Building or Use Permit Pre-Application Additions/Alterations/Accessory Structures To Detached Single Family Dwelling

Re: Porch Extension & Creation of Window Opening; 364 Spring Street

BUILDING PERMIT REPORT

DAT	E: 3/ AUG 98 ADDRESS: 364 Spring ST 661- F-601
REAS	SON FOR PERMIT: 10 MAKE GXT. Rego
BUIL	DINGOWNER: Chris HanTe
CON	TRACTOR: The Gilman Group
PERA	OUT APPLICANT:
USE	GROUP R-3 BOCA 1996 CONSTRUCTION TYPE 53
	CONDITION(S) OF APPROVAL
This	Permit is being issued with the understanding that the following conditions are met:
Appr	oved with the following conditions: 4/ 48×10×12, 426 429

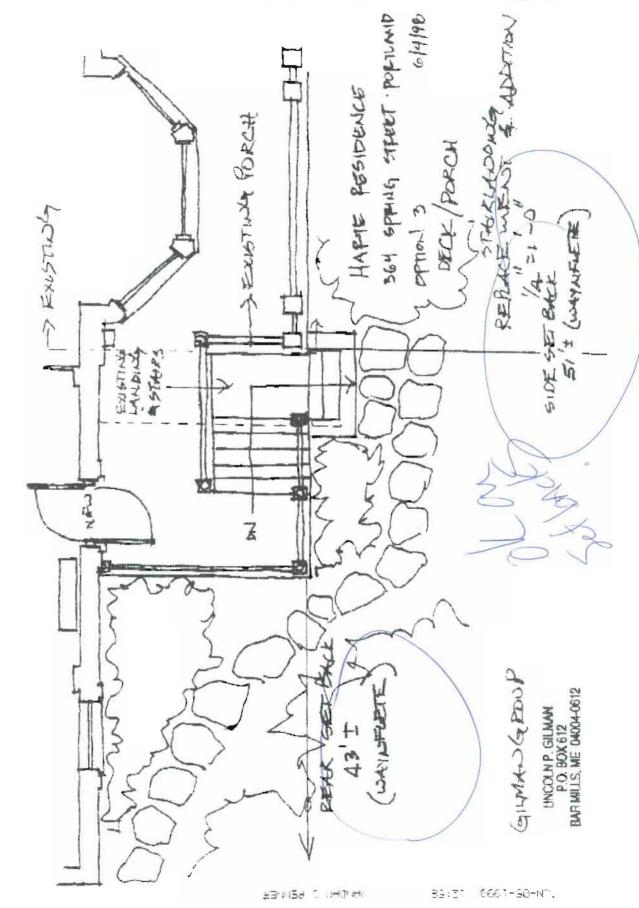
I HAVE WADE NOTATIONS ON THE PLAN THAT FOLLOWS INDICATING SET BACKS.
